## DRAINAGE AND TRANSPORTATION INFORMATION SHEET (REV 11/2018)

**Project Title:** Highland High School - Title IX Gymnasium Upgrade **Building Permit #:** 2018-11701 / 2018-11703 **Hydrology File #:** K17D021A  
**DRB#:** \_\_\_\_\_ **EPC#:** \_\_\_\_\_ **Work Order#:** \_\_\_\_\_  
**Legal Description:** \_\_\_\_\_  
**City Address:** 4700 Coal Ave SE 87108

Re: Highland HS Title IX Gym Upgrade – Hydrology Permanent CO  
COA Hydrology #K17D021A

Enclosed for your review is a copy of the above referenced project's Drainage Certification Submittal. This is the **Overall** As-Built Drainage Certification for the entirety of the Highland HS Title IX Gym Upgrades. Per your letter dated 4/3/2019, Hydrology Permanent CO was granted for phases 2, 4, 5, and 6. This submittal is in support of Hydrology Permanent CO for Phases 1 and 3. Their Building Permit #'s can be found below:

**A4 DOWN SPOUT CONNECTION DETAIL**  
N.T.S.

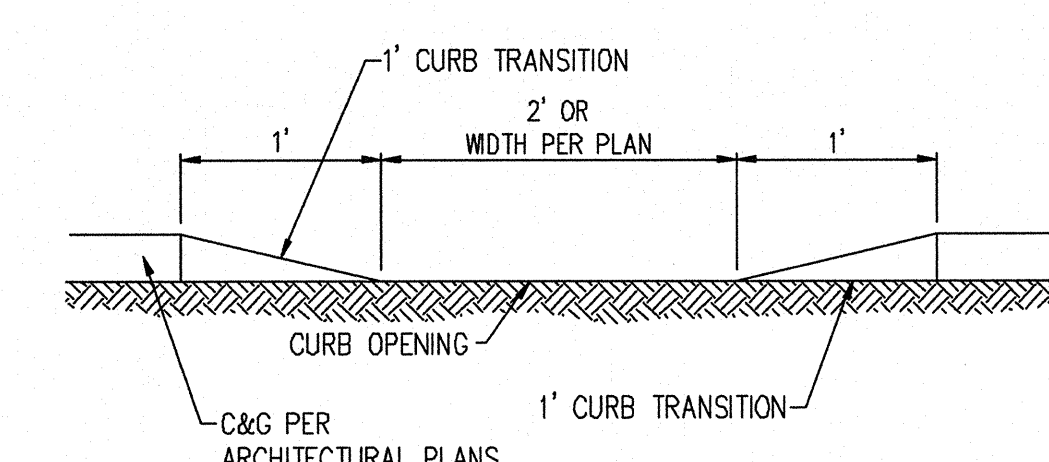
- *All construction fencing is to be removed from Phase 3*
  - Construction fencing is now removed.
- *The roof drains need to be connected to the down spouts in Phase 3*
  - Roof drains in the affected area are now properly connected.
- *Clean existing trench drain clear of debris and ensure proper function*
  - Trench drain is clean and functions.
- *Plates on all sidewalk culverts need to be bolted down in Phase 1*
  - Sidewalk culverts are bolted down.
